# Work Order ID 108964

Item Name: Dome Light Housing Assembly, Light Grey

# **D4858-041 DOME LIGHT AIR VENT ASSEMBLY**

## D4858-1 DOME LIGHT HOUSING

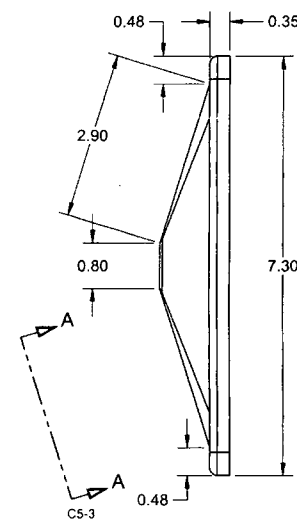
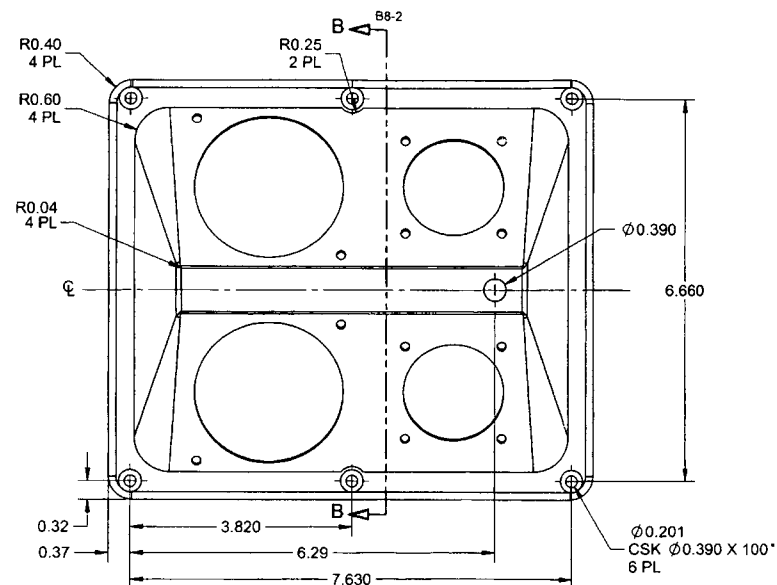
Root Cause	Date	Step	Qty	Description of work order update or Non-conformance	Initial Chief Eng	Action Description	Sign & Date	Verification	QC Inspector
Doc/Data <input type="checkbox"/>	14/3/6	110	1	Drill hole Between the existing hole without countersink hole and sign for Deviation	S 14/03/07	Rework has been accept as per Roberto  see attached email	S/H 14/03/07	DAS 27 9-89 14/3/17	S 14/03/07
Equip/Tooling <input type="checkbox"/>									
Operator <input type="checkbox"/>									
Material <input type="checkbox"/>									
Setup <input type="checkbox"/>									
Other <input type="checkbox"/>									
Process <input checked="" type="checkbox"/>									
Supplier <input type="checkbox"/>									
Training <input type="checkbox"/>									
Unapproved <input type="checkbox"/>

While tightening the screws the assembler found the screws are pulling the plastic material into the Dome Light Frame due to the countersink.

Could we drill symmetrical holes between the existing holes without countersinking and sign it of as a deviation.

As discussed, your proposal is acceptable to me.
